Rezoning Transportation Analysis

Petition Number: 2020-200

General Location Identifier: 14510317 and 14510318

Revision Log:

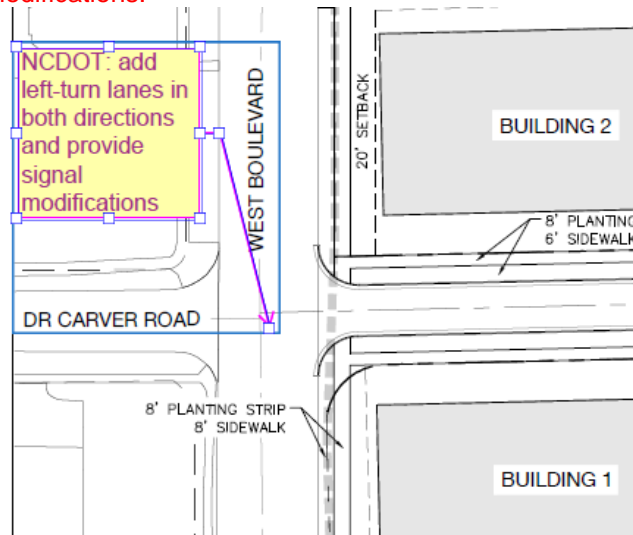
4. **Outstanding Comment (site plan dated 02-12-2021)** Revise site plan and conditional note(s) to commit to construct an 8-foot planting strip and 8-foot sidewalk on West Boulevard, as well as an 8-foot planting strip and 6-foot sidewalk on Proposed Public Roads 1 and 2, unless otherwise required

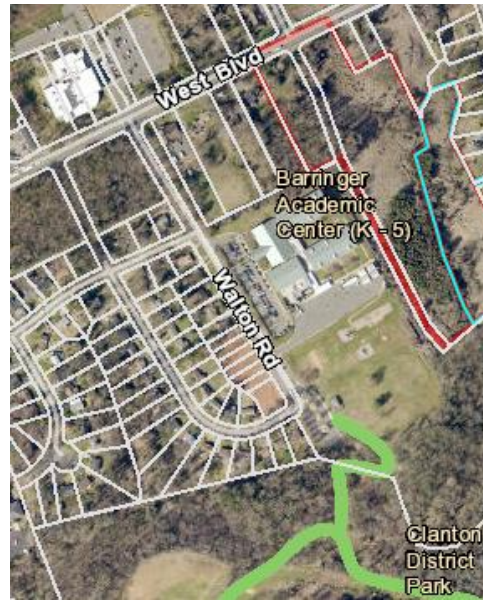
- 9. **Outstanding comment (02/12/2021 Site Plan):** Revise the site plan and conditional notes by committing to coordinate with Charlotte-Mecklenburg Schools (CMS) to provide a pedestrian connection/access to the Irwin Creek Greenway. The ICG currently has a trailhead located within the adjacent property of the Berringer Academic Center.

Update to Comment (01-12-2021 Site Plan): Include the conditional note to coordinate with CMS to make the connection to the Irwin Creek Greenway Trailhead.

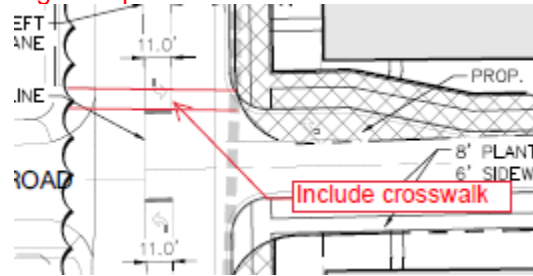
10. **Outstanding Comment (site plan dated 02-12-2021):** Revise the site plan and conditional notes by committing to coordinate with CATS, during permitting, to make improvements to the existing bus stop on West Boulevard. The site plan needs to show the existing bus stop.

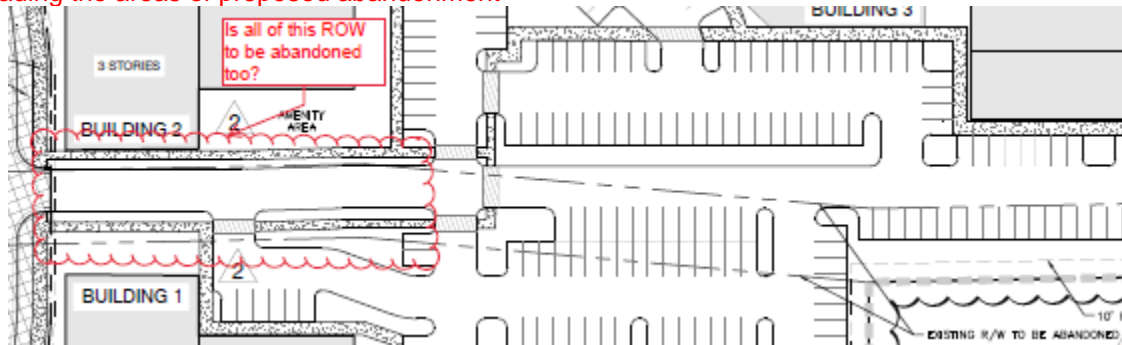
13. **Outstanding Comment (01-12-2021 site plan):** Revise the site plan and conditional notes to commit to restriping the existing crosswalk, the Dr. Carver/Public Road 1 and West Boulevard intersection, in addition to the turn-lane and signal improvements.
